MONARCH VILLAGE

Residential Redevelopment

ISSUED FOR TAC

**Re: Application for Site Plan Review
"Monarch Village"
Assessor's Map 297, Lot 6
3548 Lafayette Road
Altus Project No. 5161**

DEMOLITION PLAN

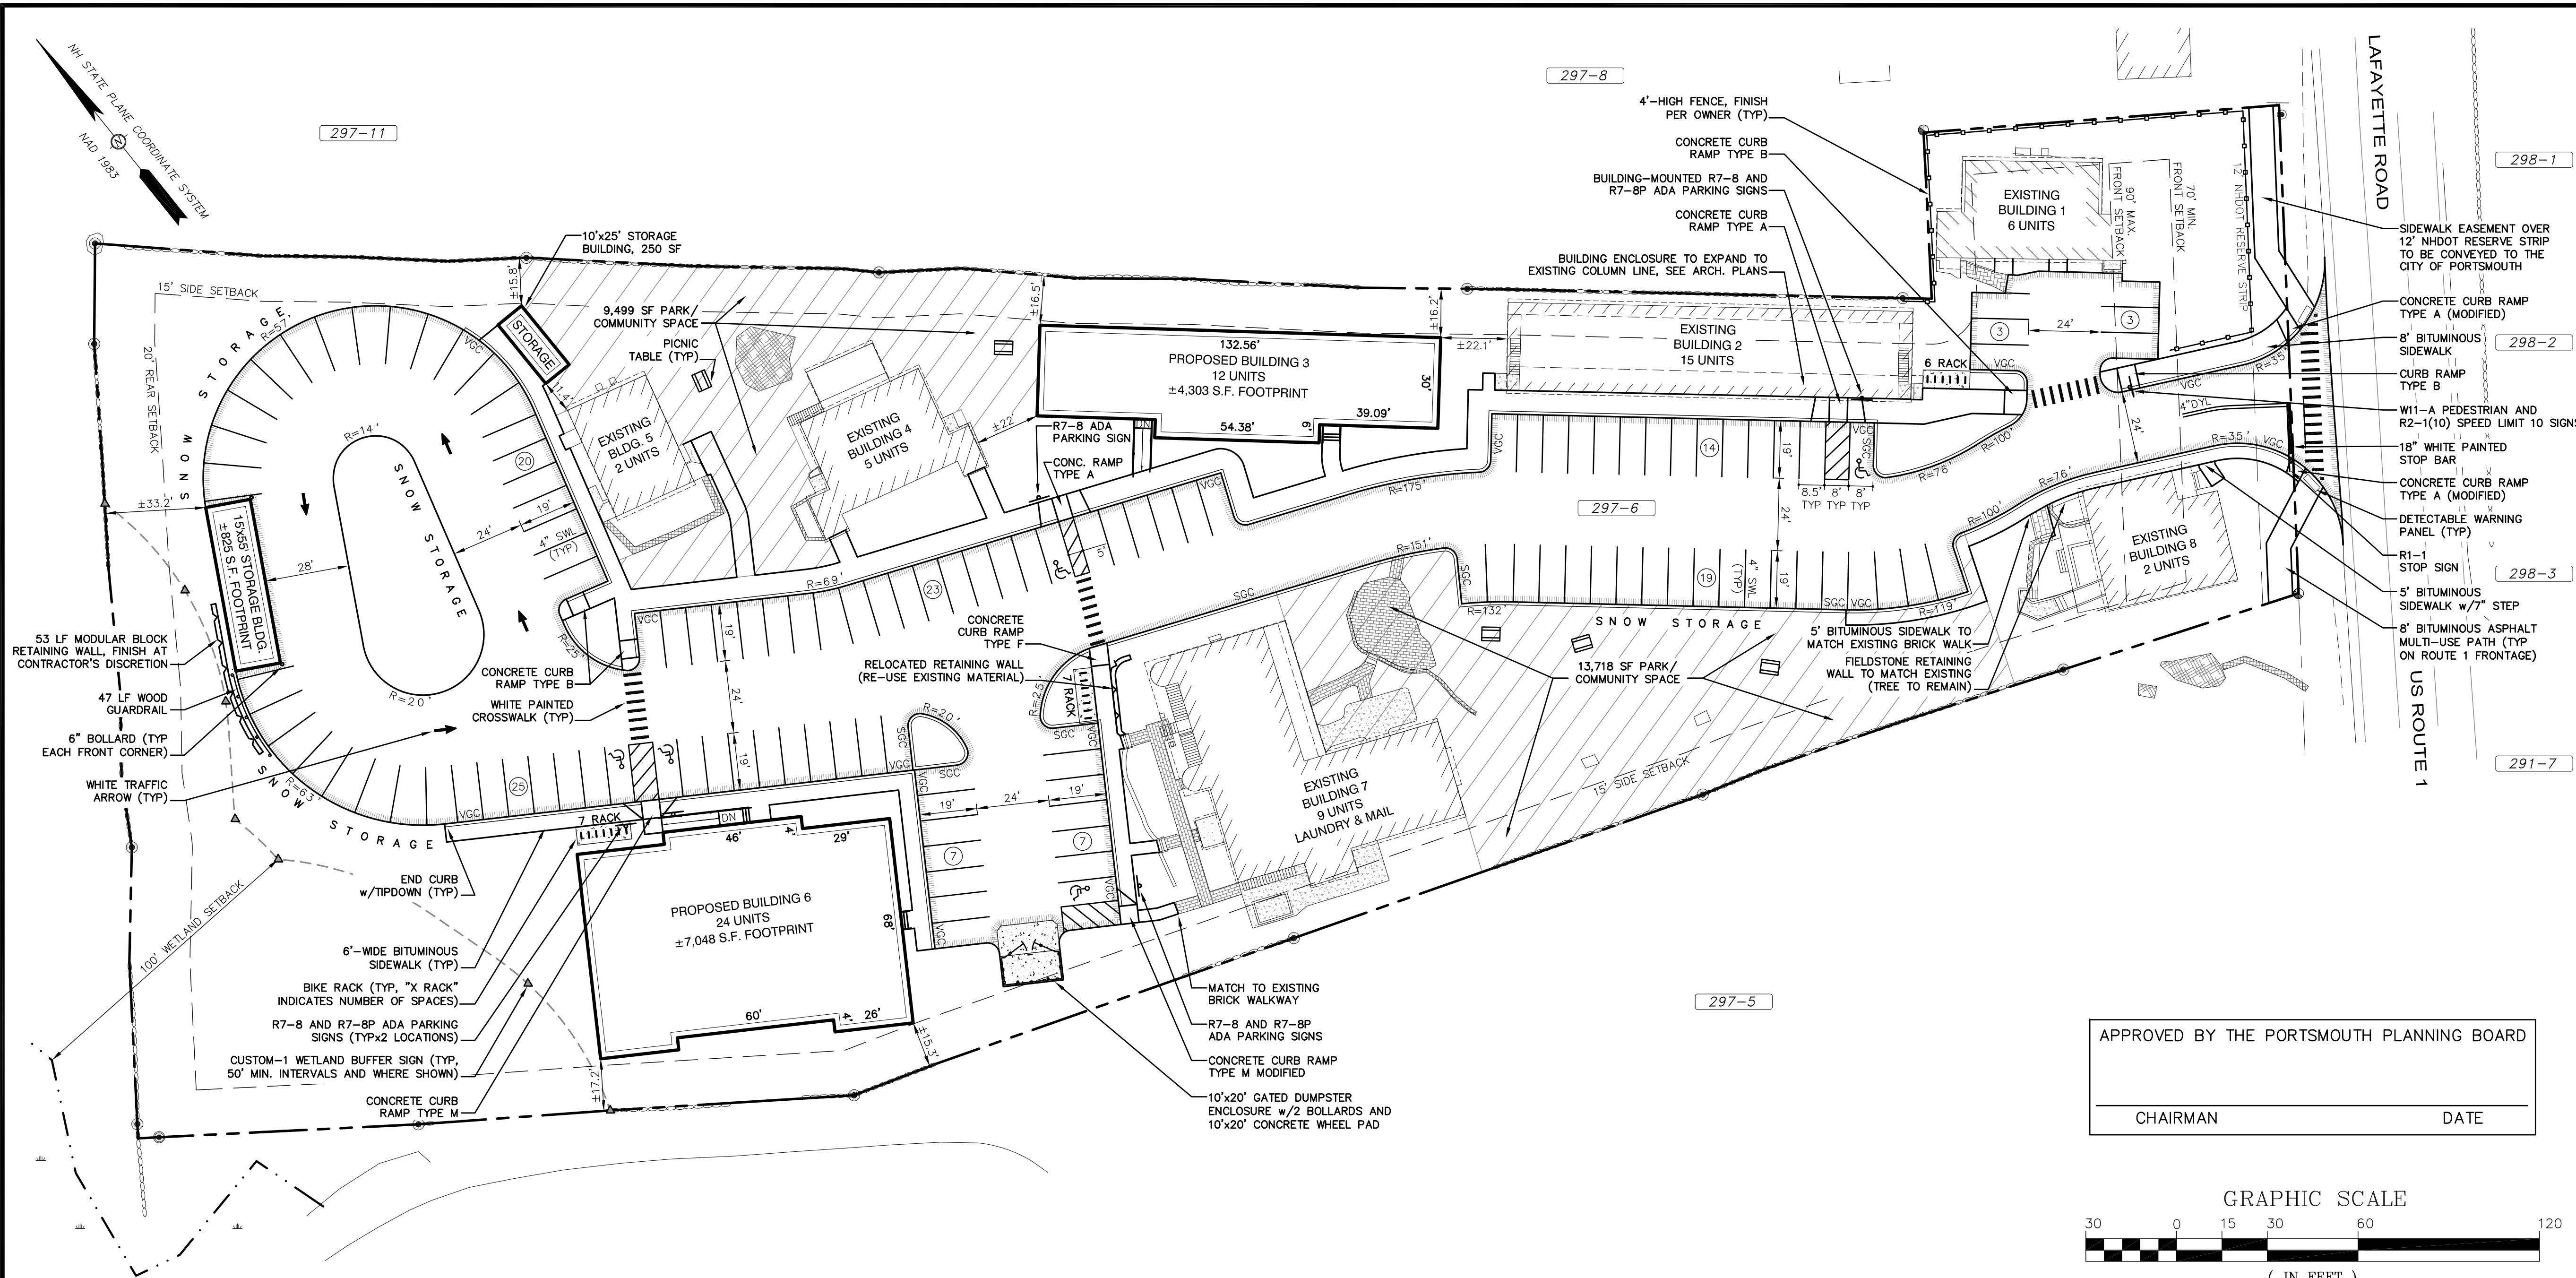
12. *The demolition plan should be updated to reflect the drainage revisions received on 10/28/2021.*

SHEET NUMBER: EXH-2

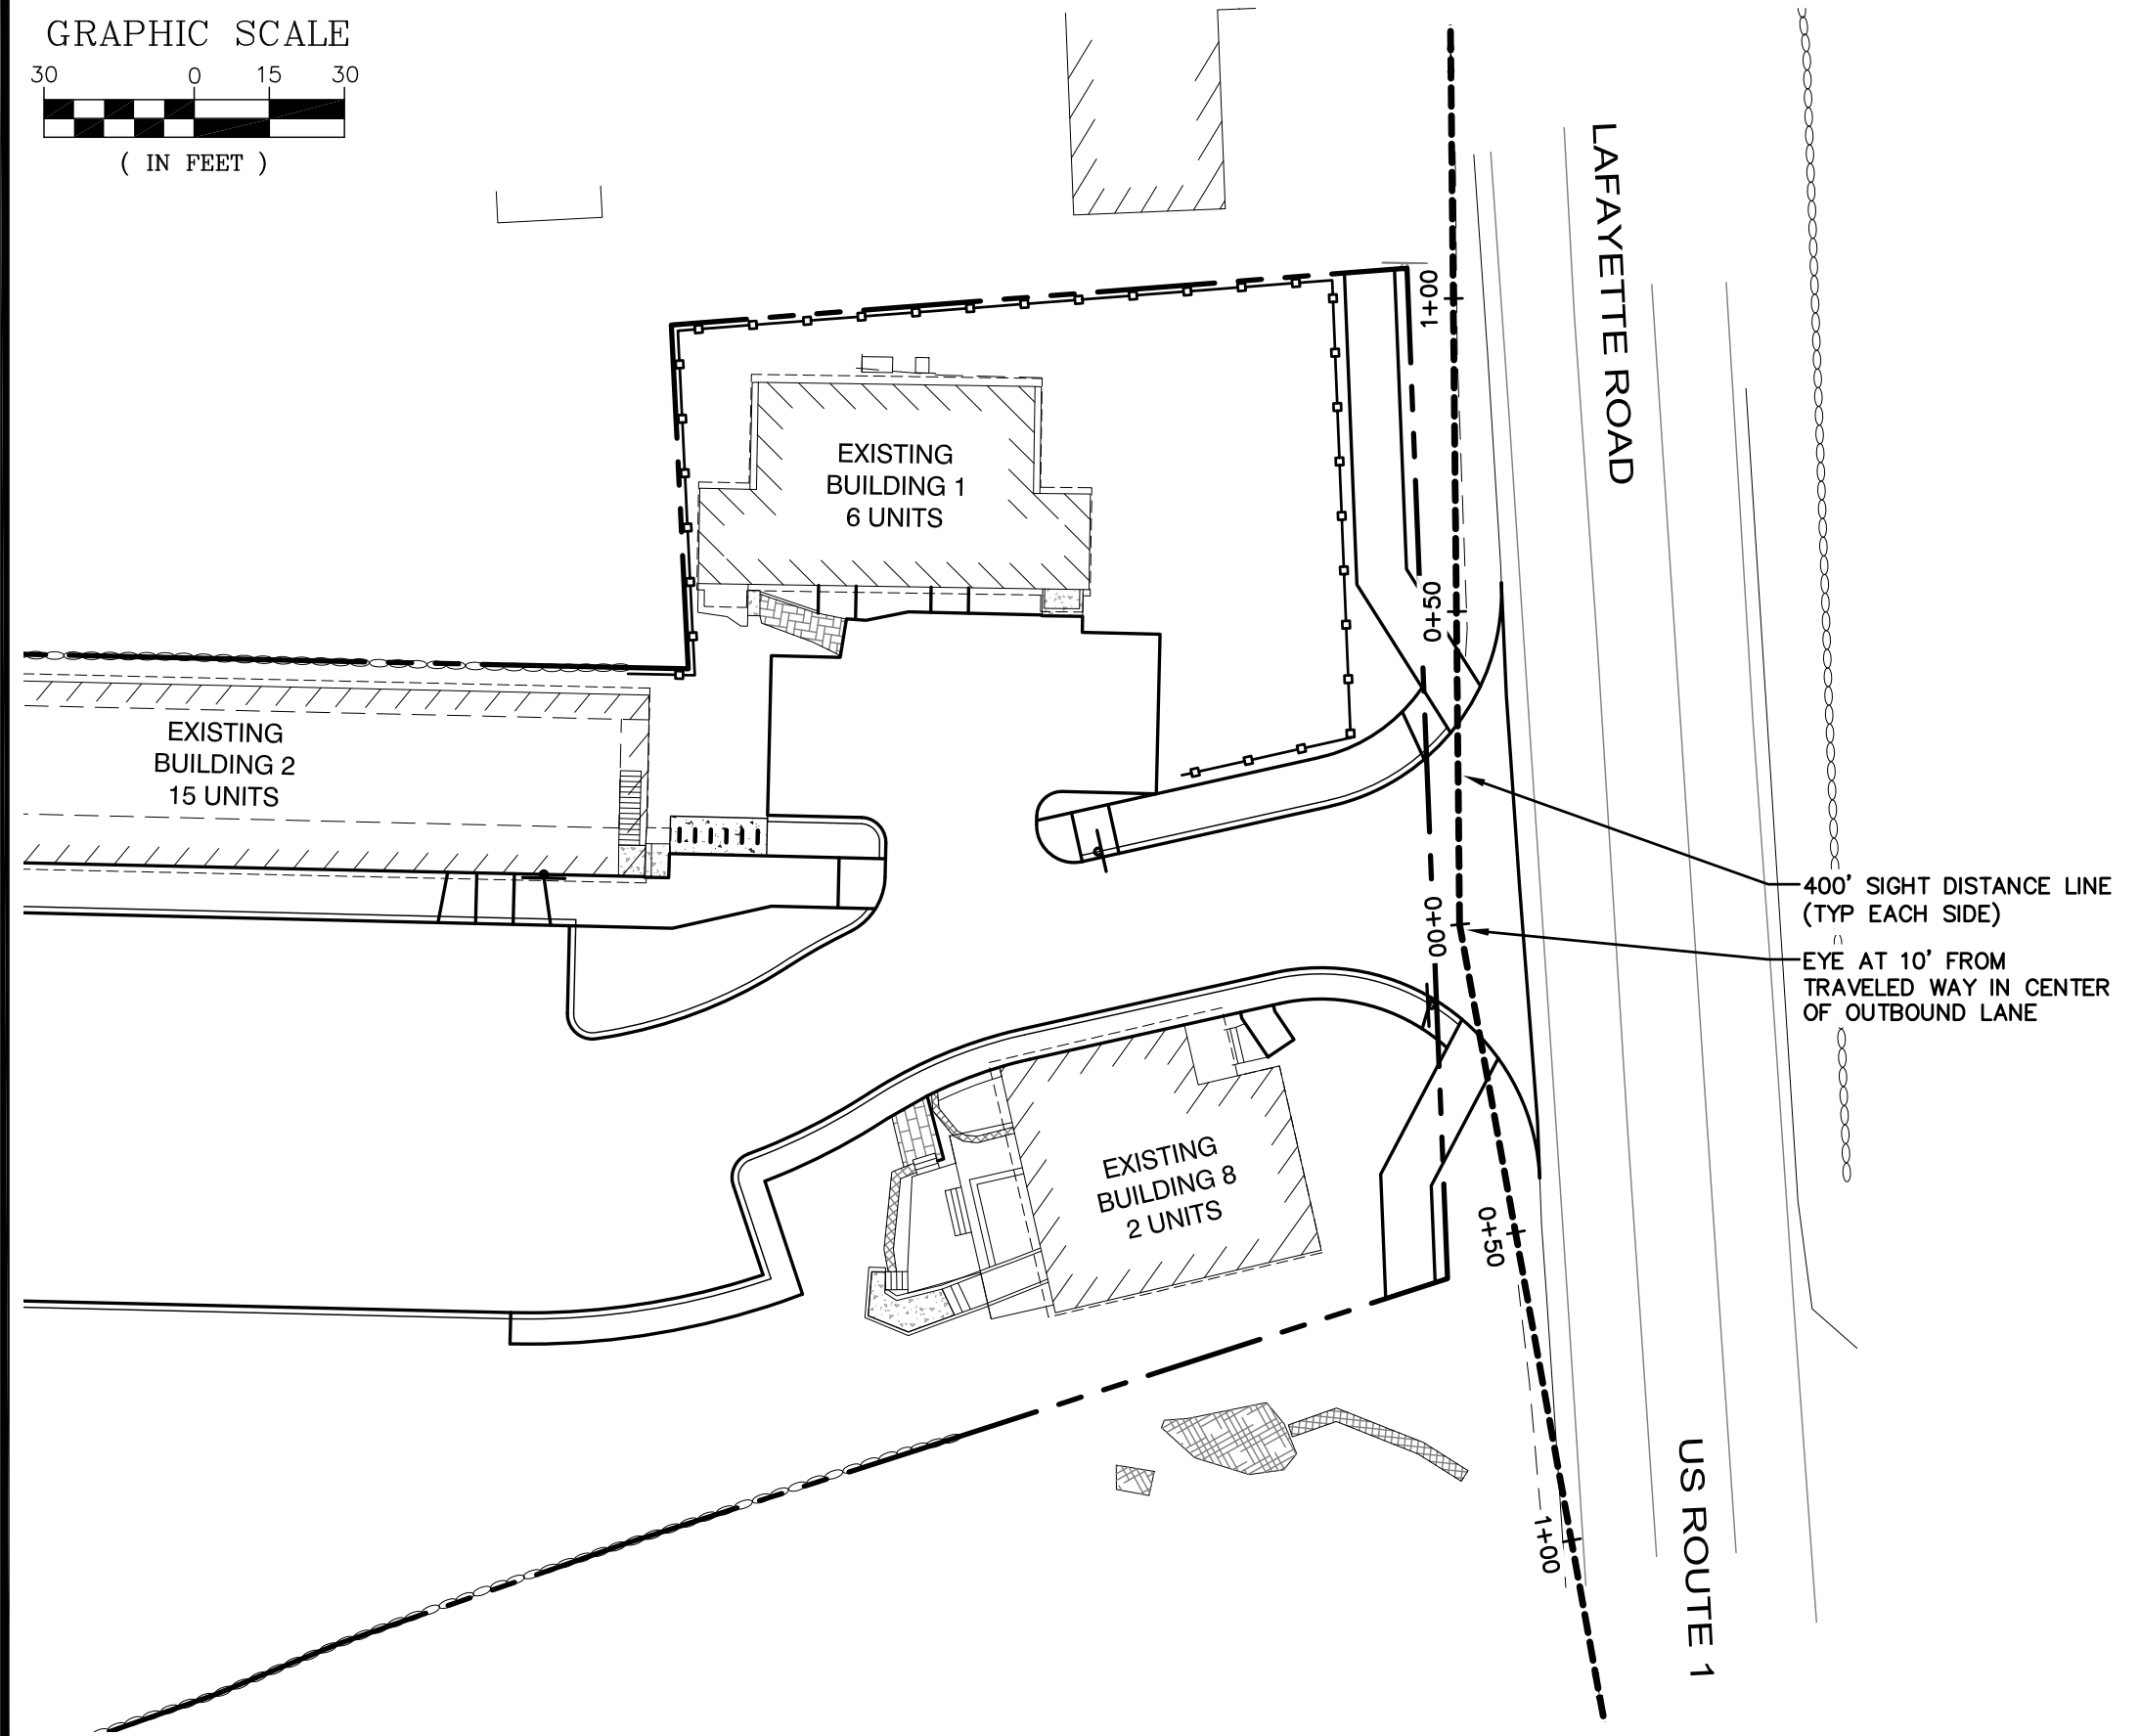
10. The Applicant should provide turning templates showing the ability of a refuse vehicle access the proposed dumpster area and egress the site through the circulation pattern without conflicting with parked vehicles.

10. A trash truck turning template has been prepared and included with this correspondence.
11. TEC agrees that the design vehicle, in this case an Inferno ladder truck, can safely navigate the site but defers to the Fire Department for approval. No comment required.
